ADDENDUM NO. 01

March 4, 2024

TO: ALL HOLDERS for the Requests for the 2023 Pavement Rehabilitation Project – C9416

PROJECT NO. C9416

Scale: As Shown
Design By: MA
Drawn By: RCB
Checked By: REB
Sheet Number
C2.4
6 of 125 Sheets

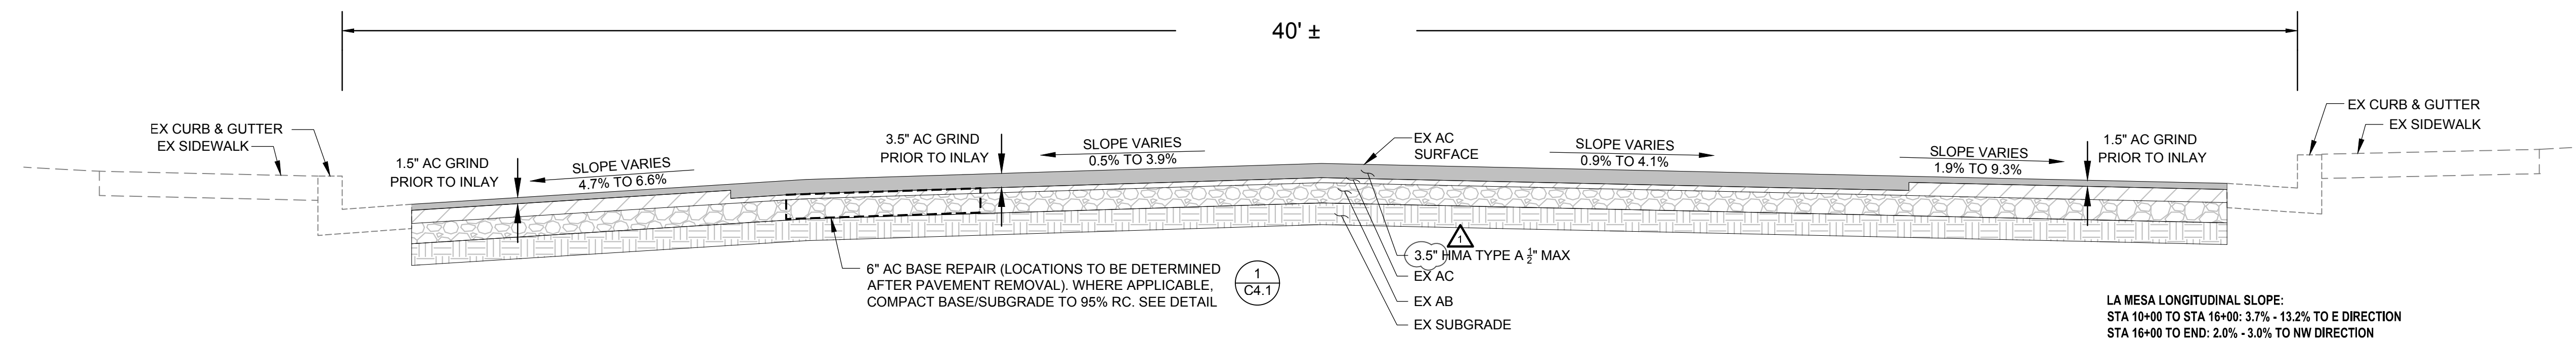
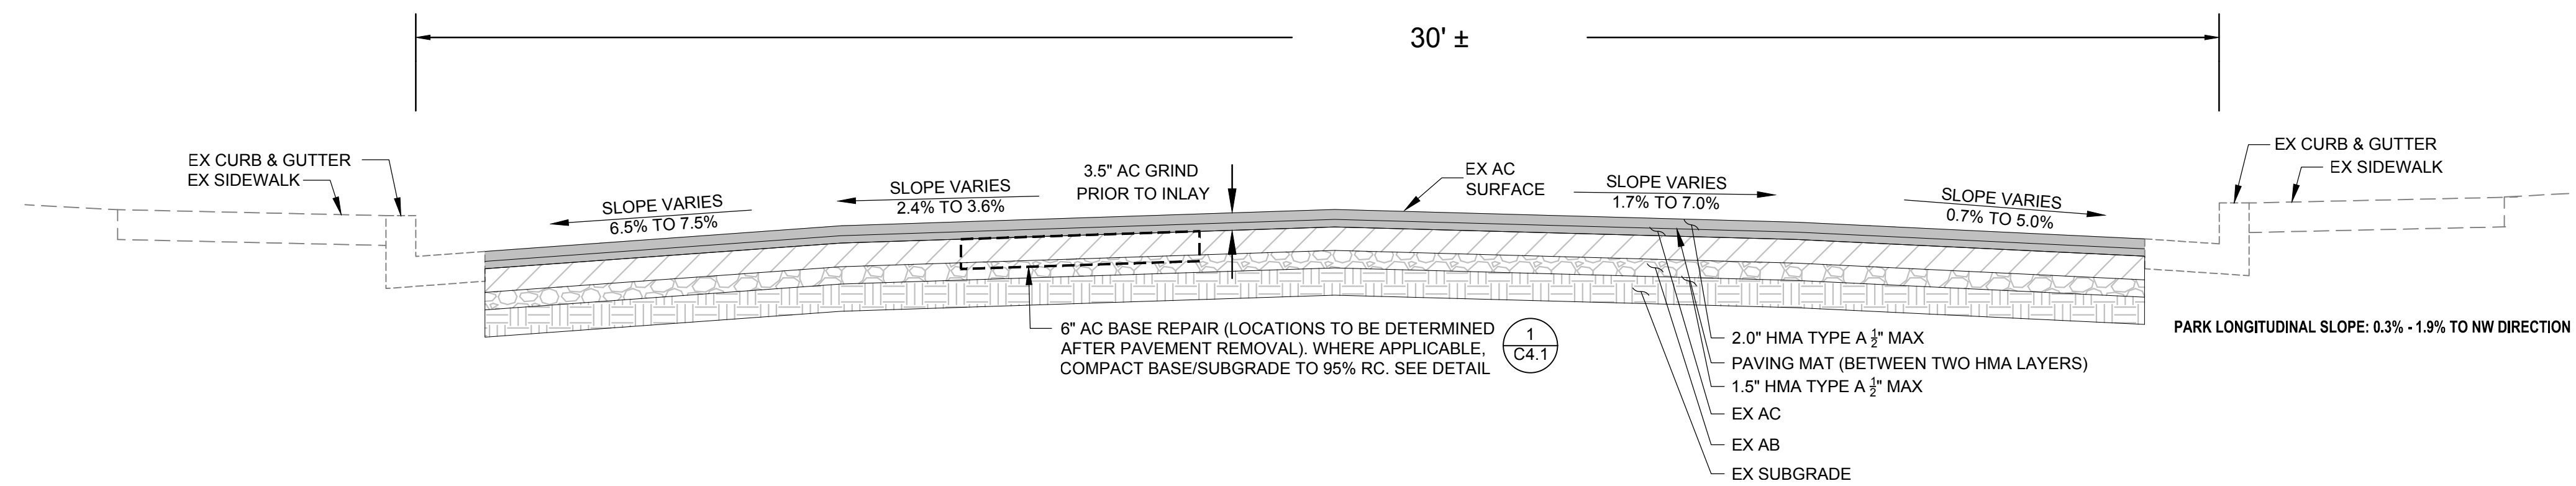
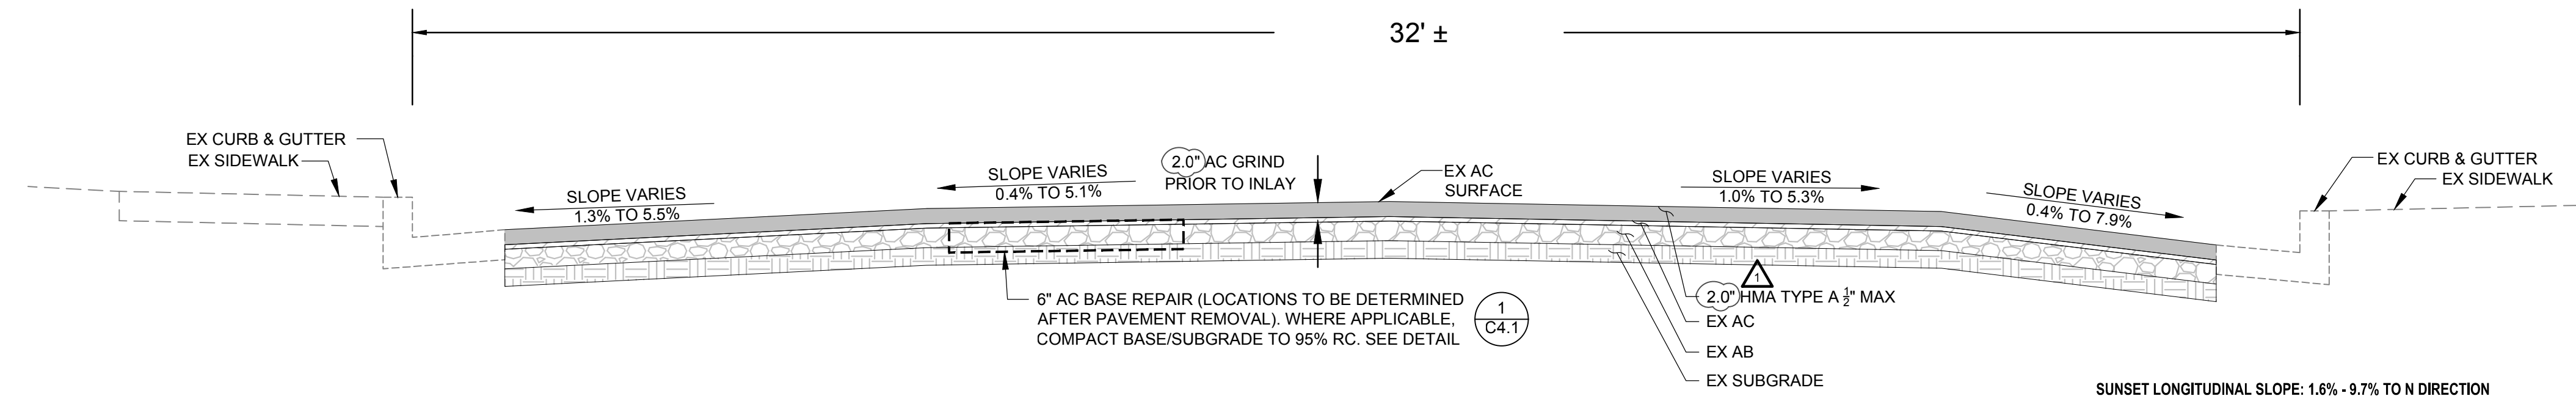
- Sheet C2.4 – Typical Sections
- Sheet C2.6 – Typical Sections
- Sheet C3.11 – Improvement Plan – Chestnut Street
- Sheet C3.13 – Improvement Plan – Chestnut Street
- Sheet C3.16 – Improvement Plan – Garnet Avenue
- Sheet C3.20 – Improvement Plan – La Mesa Drive
- Sheet C3.21 – Improvement Plan – La Mesa Drive
- Sheet C3.22 – Improvement Plan – La Mesa Drive
- Sheet C3.23 – Improvement Plan – Park Avenue
- Sheet C3.34 – Improvement Plan – Woodland Avenue
- Sheet C3.82 – Improvement Plan – Park Avenue
- Sheet C3.83 – Improvement Plan – Park Avenue
- Sheet C3.105 – Improvement Plan – Woodland Avenue 1
- Sheet C3.106 – Improvement Plan – Woodland Avenue 2

C3.13

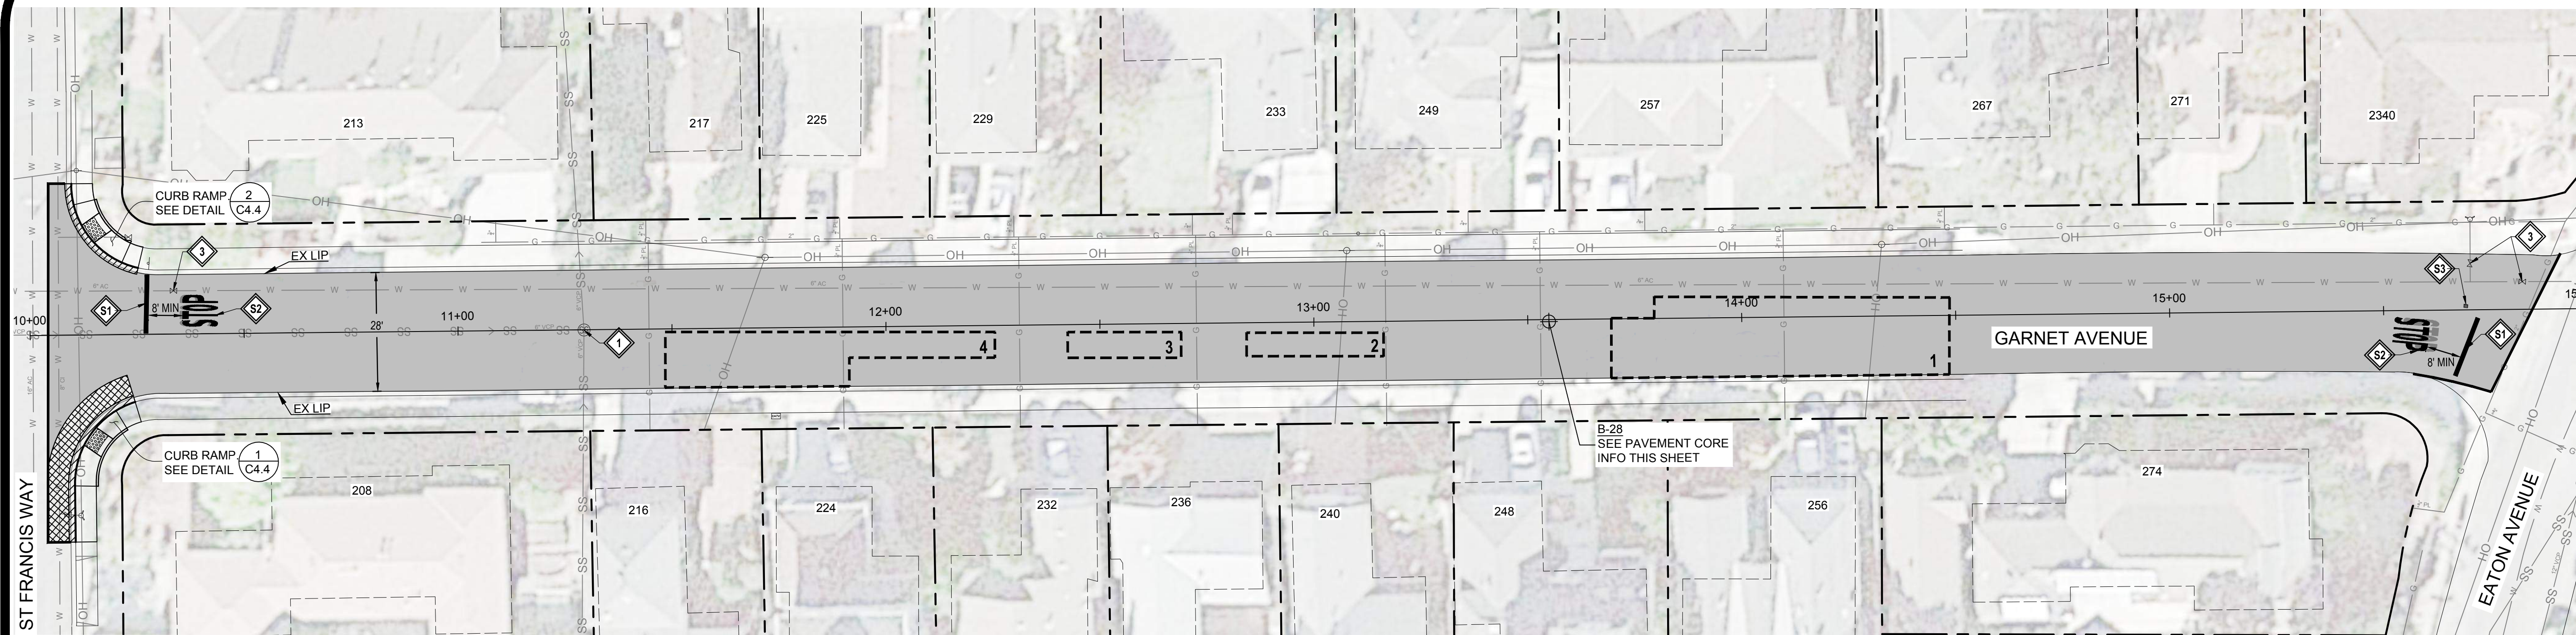
NO.	DESCRIPTION	BY	DATE
1	REVISION 1	RB	02/26/24

Scale: As Shown
Design By: MA
Drawn By: RCB
Checked By: REB
Sheet Number
C3.16
25 of 125 Sheets

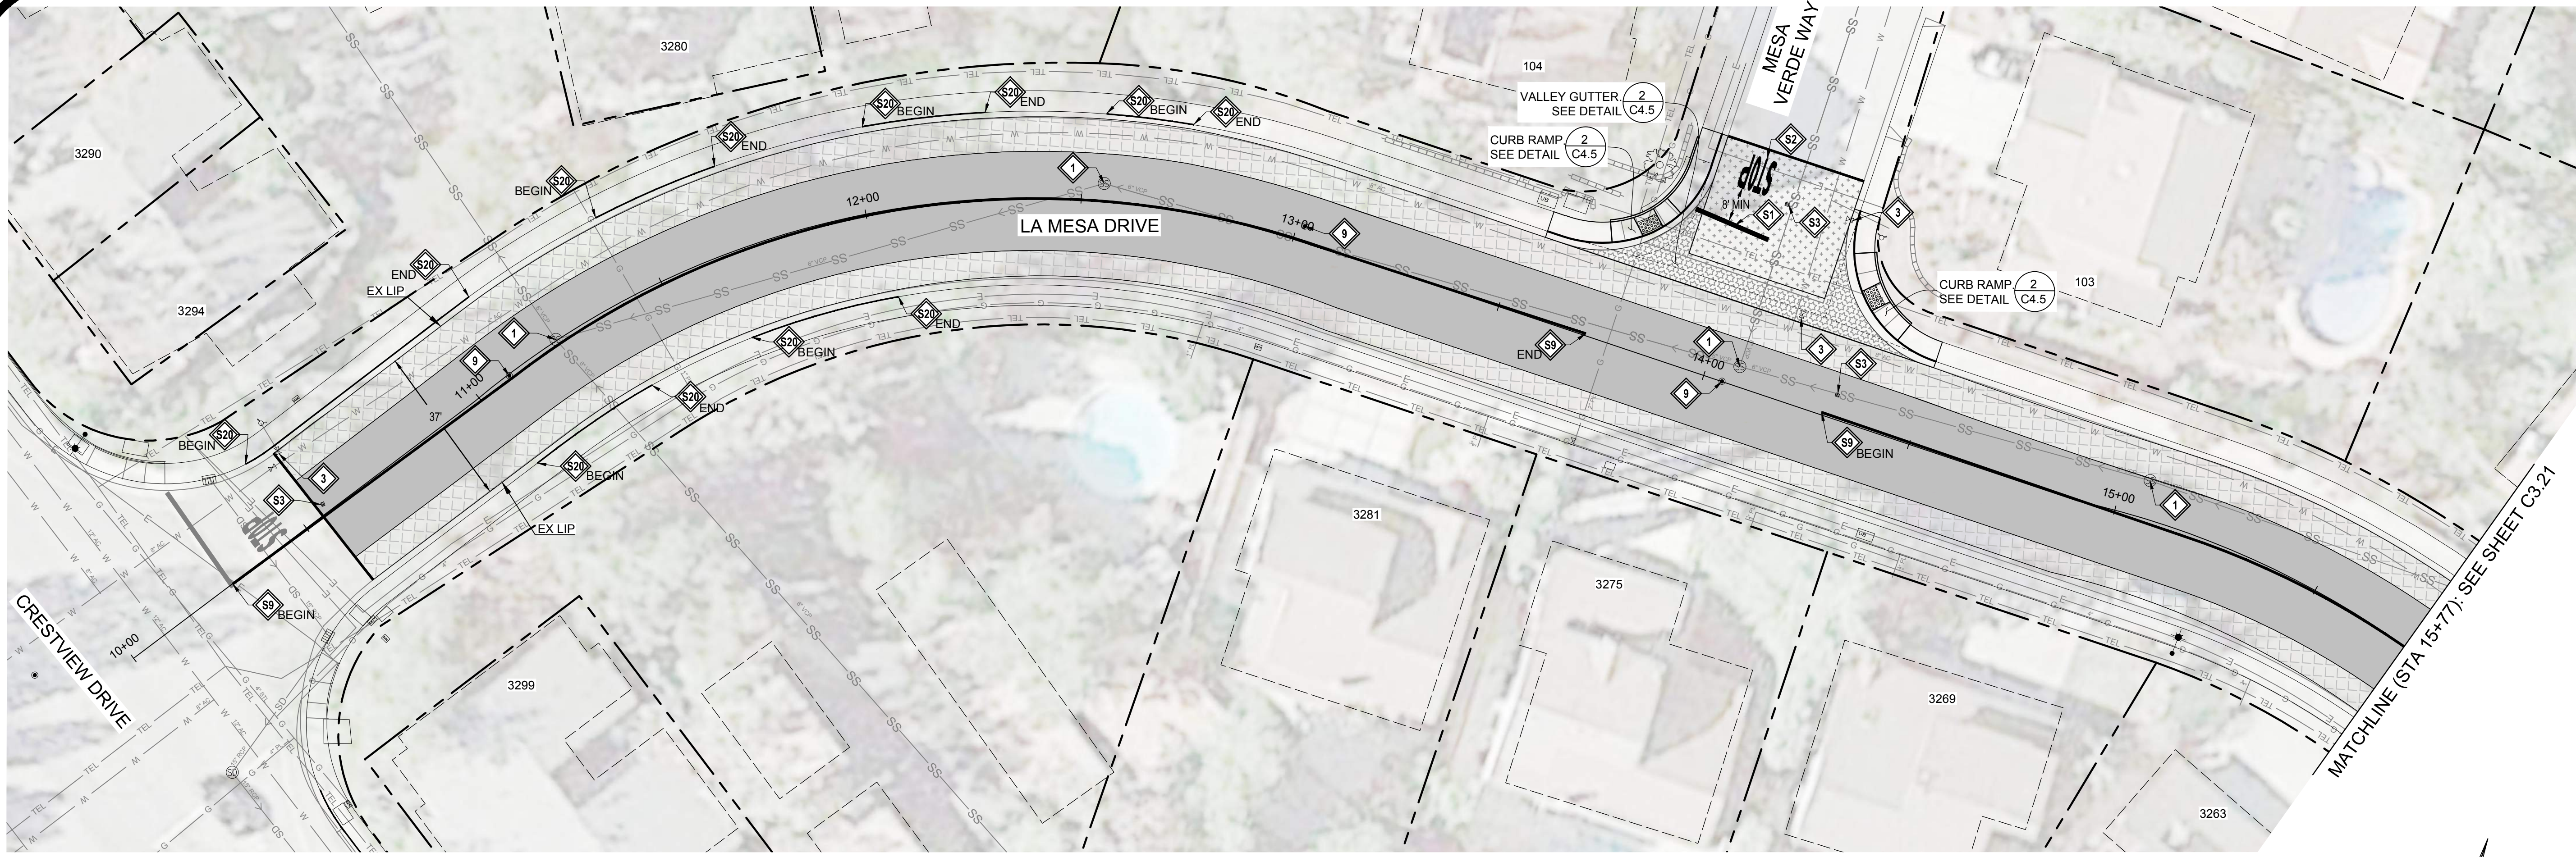
NO.	DESCRIPTION	BY	DATE
1	REVISION 1	RB	02/26/24
